UNITED STATES PATENT AND TRADEMARK OFFICE

APPLICATION NO.	FILING DATE	FIRST NAMED INVENTOR	ATTORNEY DOCKET NO.	CONFIRMATION NO.
10/707,214	11/26/2003	Bruce Albrecht	ITW7510.073	1213

Office Action Summary	Application No.	Applicant(s)	
	10/707,214	ALBRECHT ET AL.	
	Examiner	Art Unit	
	Jeffrey Sharp	3677

DETAILED ACTION

Duffy et al. US-5,685,680

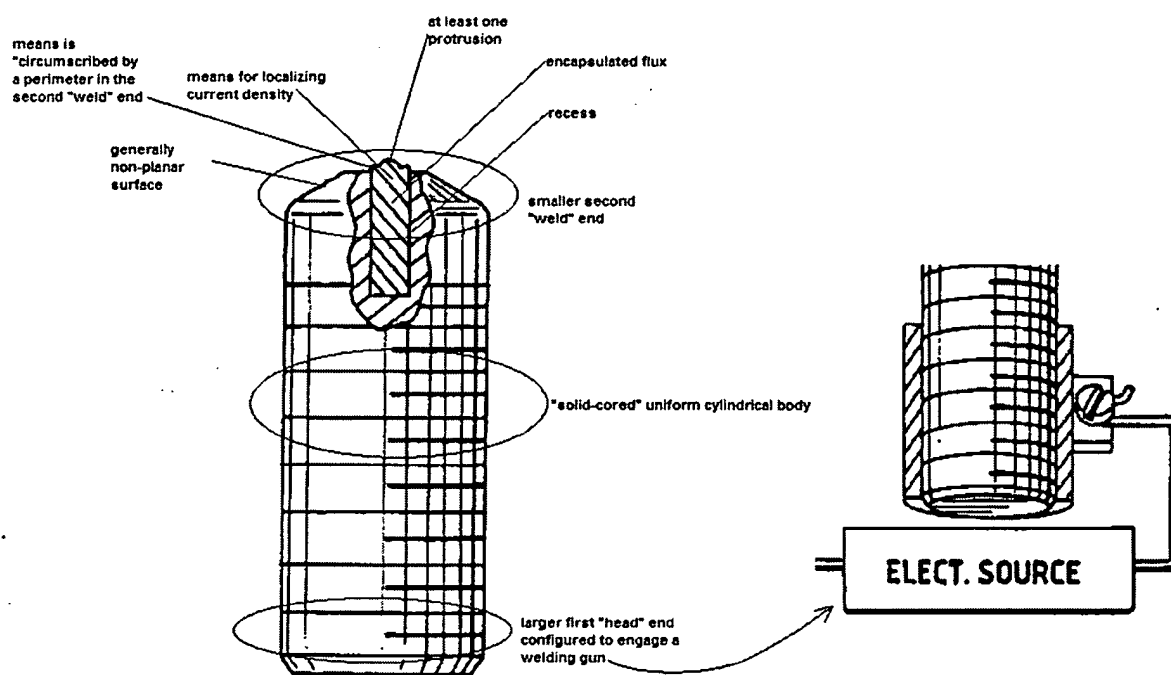
[8] Claims 1-3, 6, 10, 12, 18 (as it is understood), 19 (as it is understood), 23 (as it is understood), 24 (as it is understood), 25, 27, 28, and 29 are rejected under 35 U.S.C. 102(b) as being anticipated by Duffy et al. US-5,685,680.

In short, Duffy et al. teach a weld stud having a first "head" end, a second reduced end having a "nipple" or "at least one protrusion" to direct current flow to a "workpiece" or "connector". The body has a solid core with a generally uniform cylindrical shape. The second end is "generally non-planar surface". The second end comprises a "recess", and also comprises a flux packet which is "encapsulated". In its broadest sense, Duffy et al. discloses a "means for localizing current density generally uniformly about a majority of an area circumscribed by a perimeter of the face of the weld (i.e., second) end" of the stud.

Irimies US-5,493,833

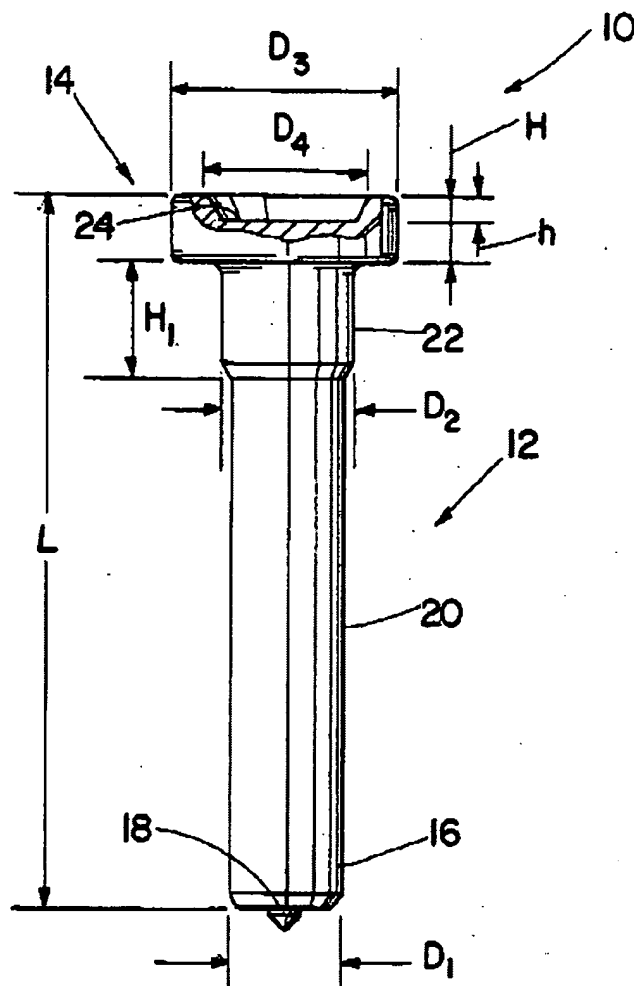
[9] Claim 1-3, 6, 7, 10, 12, 16 (as it is understood), 18 (as it is understood), 19 (as it is understood), 23 (as it is understood), 24 (as it is understood), 25, 27, 28, and 29 are rejected under 35 U.S.C. 102(b) as being anticipated by Irimies US-5,493,833.

In short, Irimies teaches a weld stud having an outwardly extending flange (i.e., "head") at a first end, a solid-cored cylindrical body, and a second reduced weld end adapted to be joined to a workpiece or connector, said second end having a recess from which at least one protrusion (i.e., encapsulated flux packet, "nipple") extends.

Rohe US-2,784,758

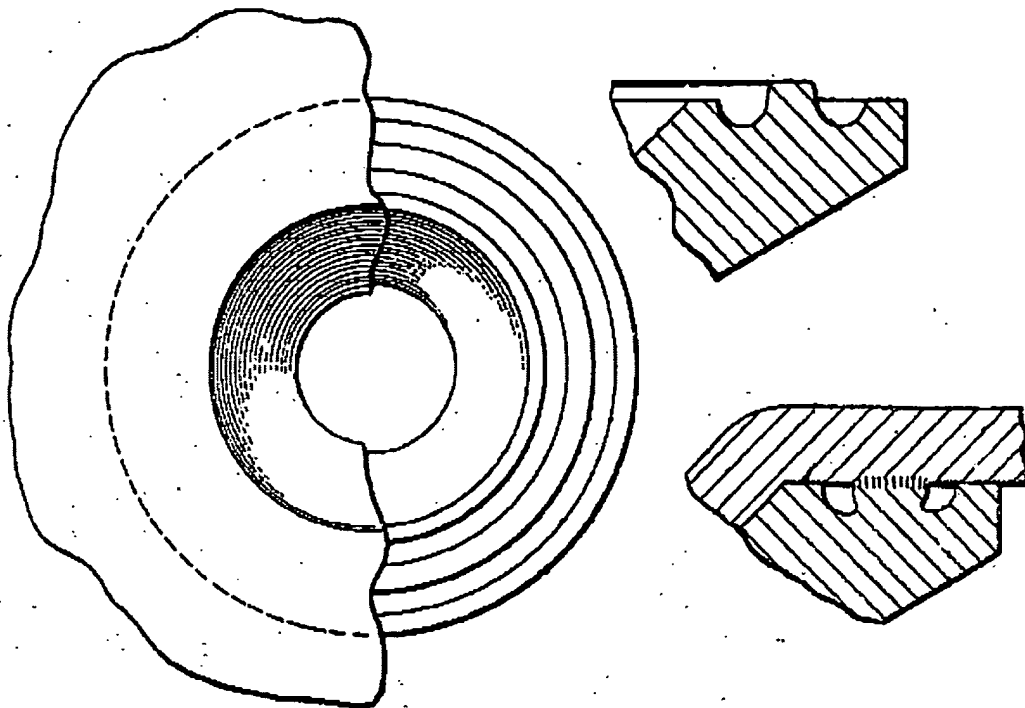
[11] Claims 4, 5, 8, 9, 11, 13, 14, 15, 16 (as it is understood), 17 (as it is understood), 20-22 (as they are understood), and 26 are rejected under 35 U.S.C. 103(a) as being unpatentable over Duffy et al. US-5,685,680 in view of Rohe US-2,784,758.

However, Duffy fails to disclose expressly, employing a plurality of ridges and grooves on the second (i.e., "weld") end.

Rohe suggests an improved welding second surface for a weld stud comprising a plurality of annular, concentric, ridges and grooves (i.e., "recesses"), so as to 1) enable the stud to be welded to thin substrates, 2) provide an advantageous means for locating, 3) to centralize and localize welding currents in a dispersed and even manner, and 4) to concentrate the welding temperature at the ridges. These ridges and grooves could also provide aesthetic advantages, prevention of weld splash, and/or a channel means for guiding flux evenly around the stud.

At the time of invention, it would have been obvious to one of ordinary skill in the art, to modify the second "weld" end taught by Duffy et al., by providing a plurality of annular, concentric, ridges and grooves (i.e., "recesses") as suggested by Rohe, so as to 1) enable the stud to be welded to thin substrates, 2) provide an advantageous means for locating, 3) to centralize and localize welding currents in a dispersed and even manner, and 4) to concentrate the welding temperature at the ridges. These ridges and grooves could also provide aesthetic advantages, prevention of weld splash, and/or a channel means for guiding flux evenly around the stud.
